BID MEMO 01

<u>Saints - Cafeteria & Viewing Area</u>

REVISION #01

New Orleans Saints Viewing Area and Cafeteria Expansion 5800 Airline Drive Metairie, Louisiana 70003

DRAWN BY I WDG A2.03

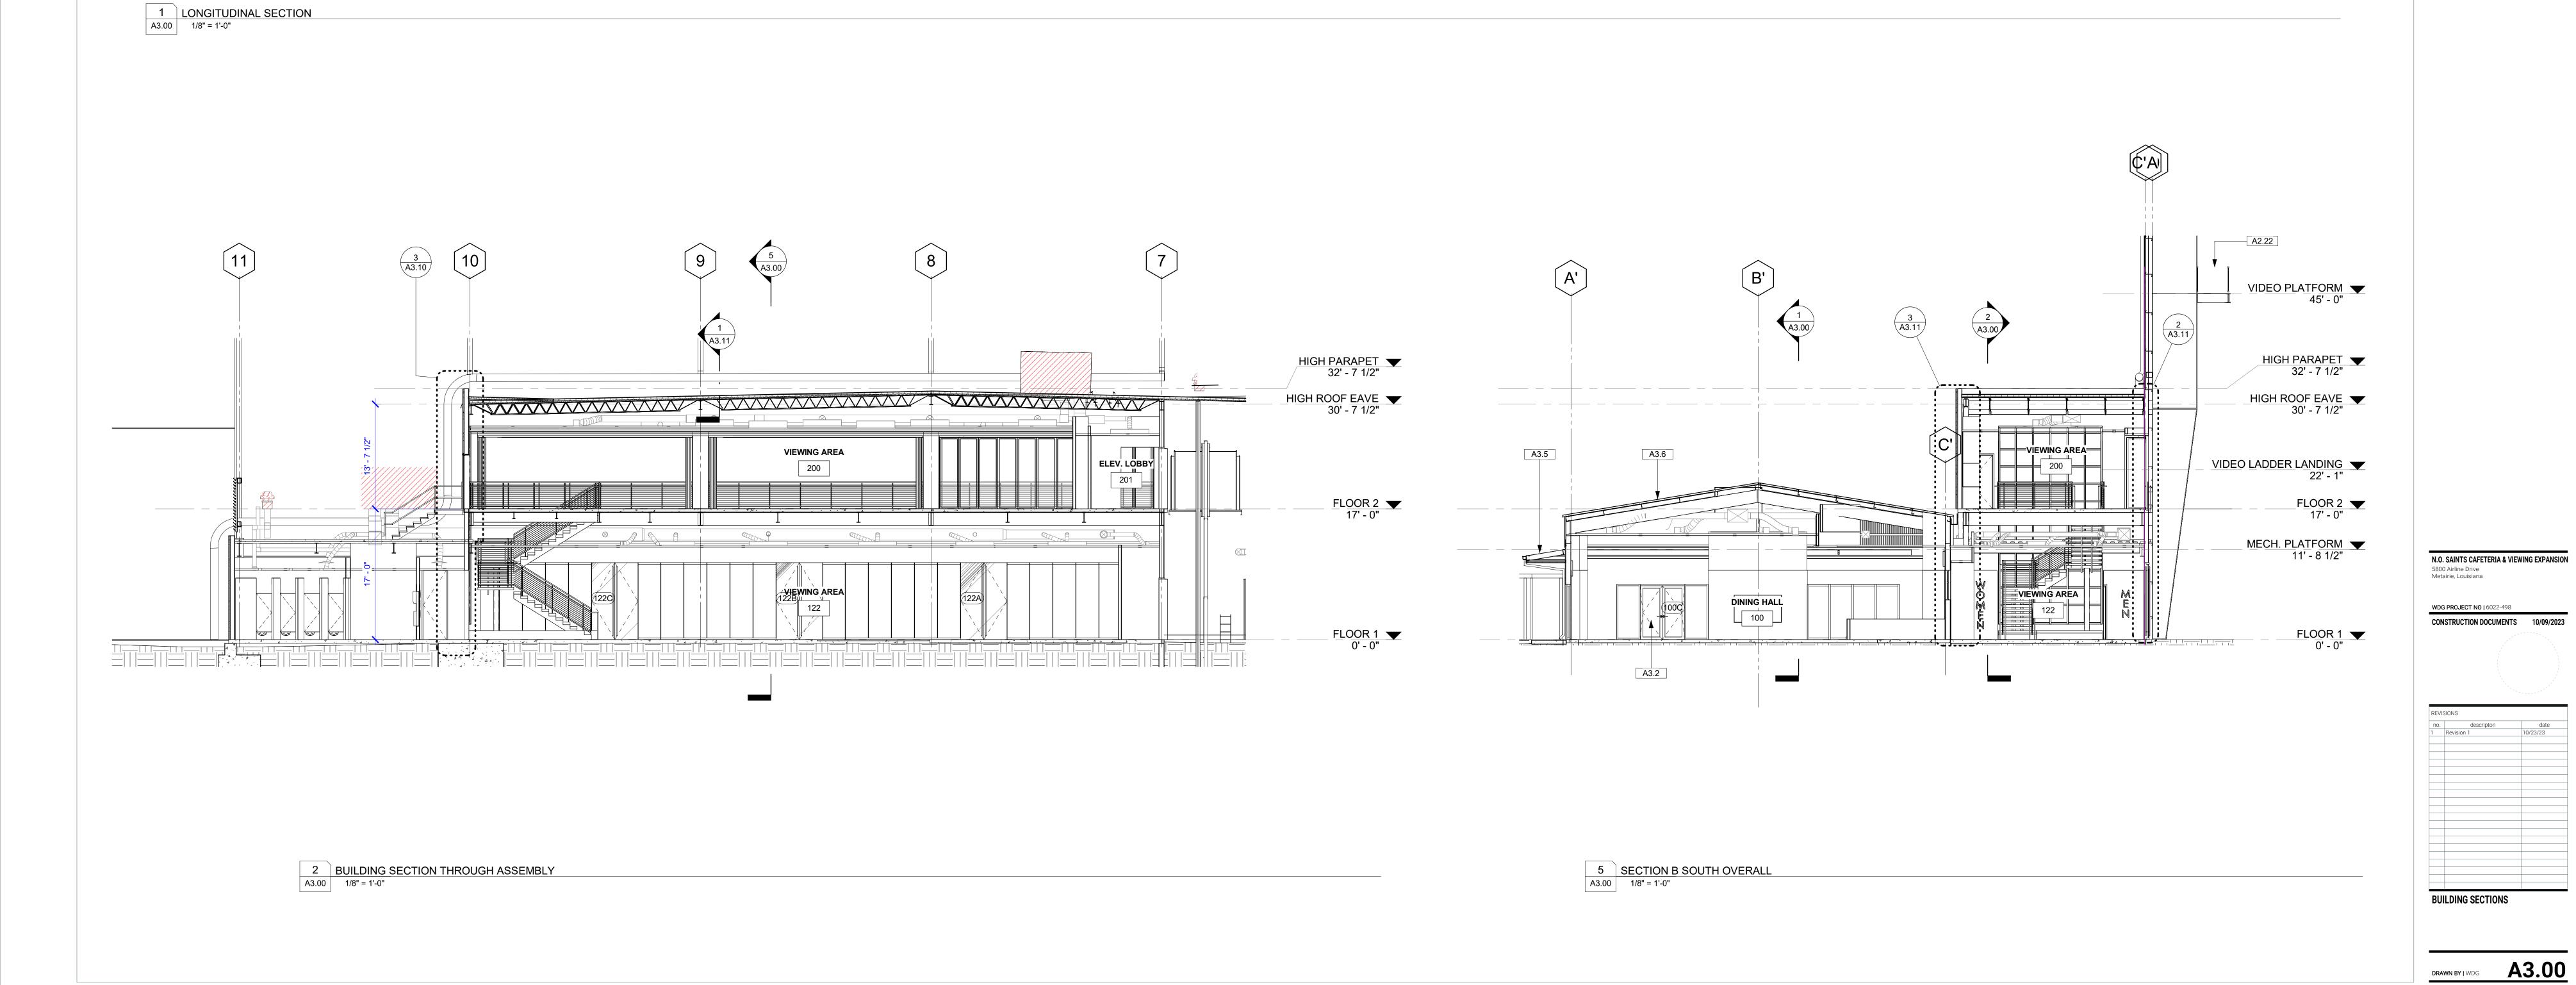
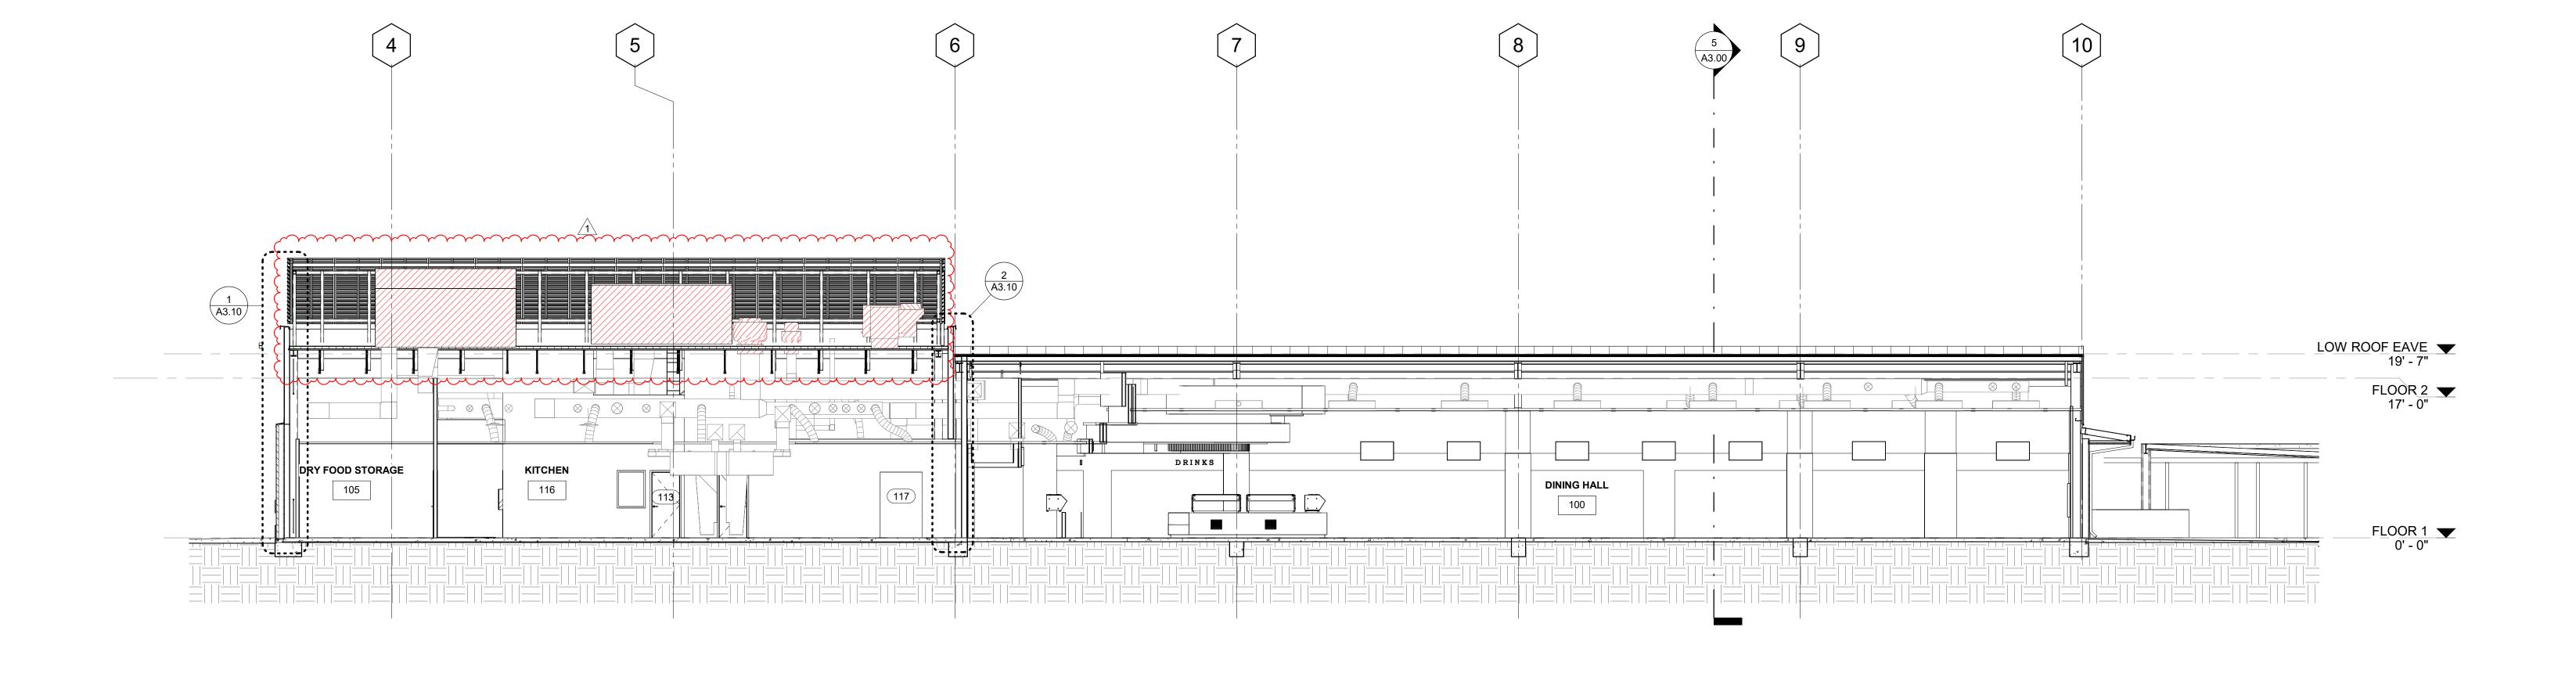
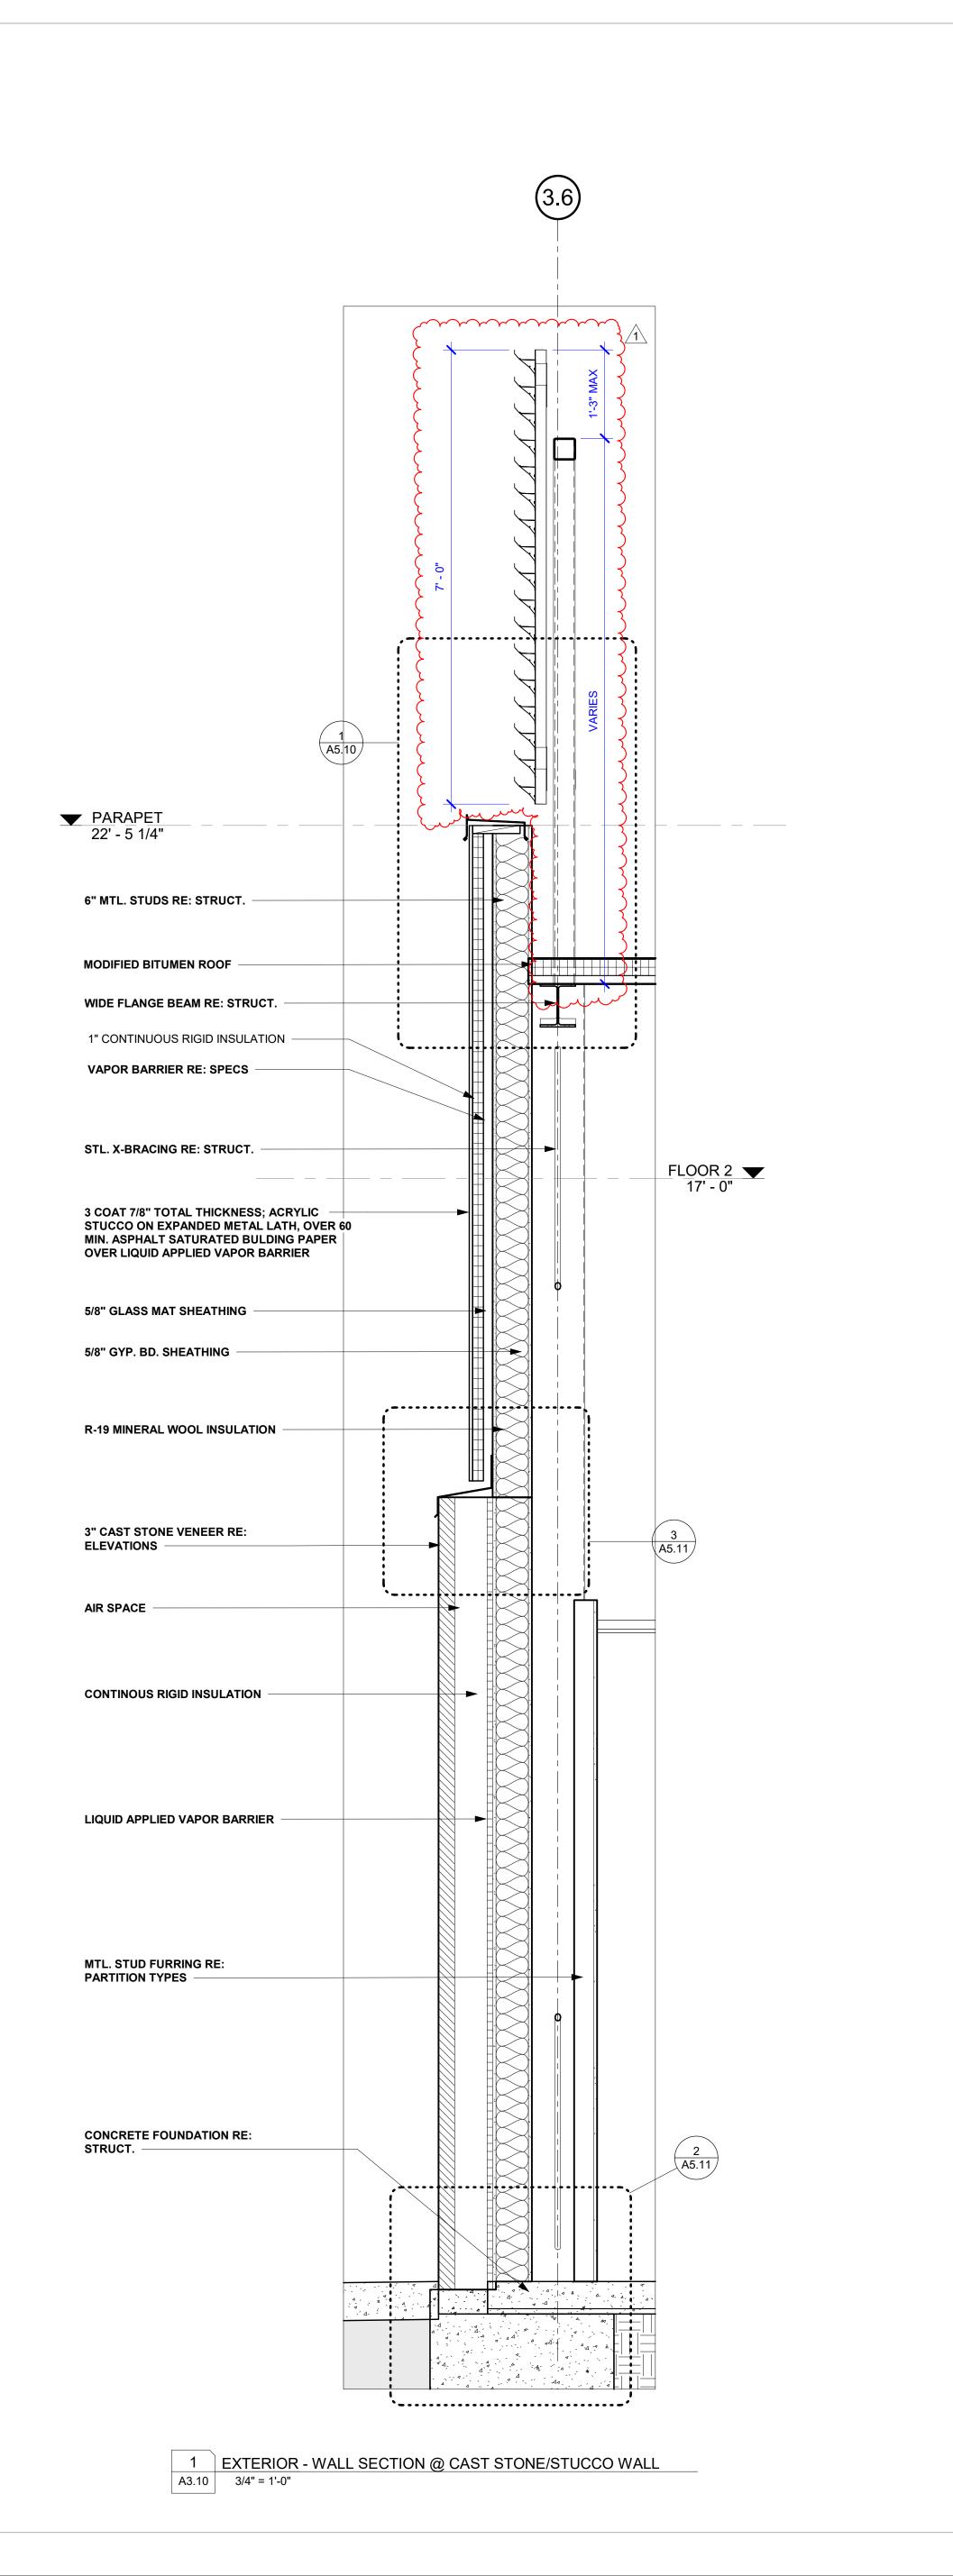
- Mechanical screen updated with new section A2.00 & A2.01
- Outdoor seating area detailed with wood planks for bench with revised chamfered corners at planters - A2.03
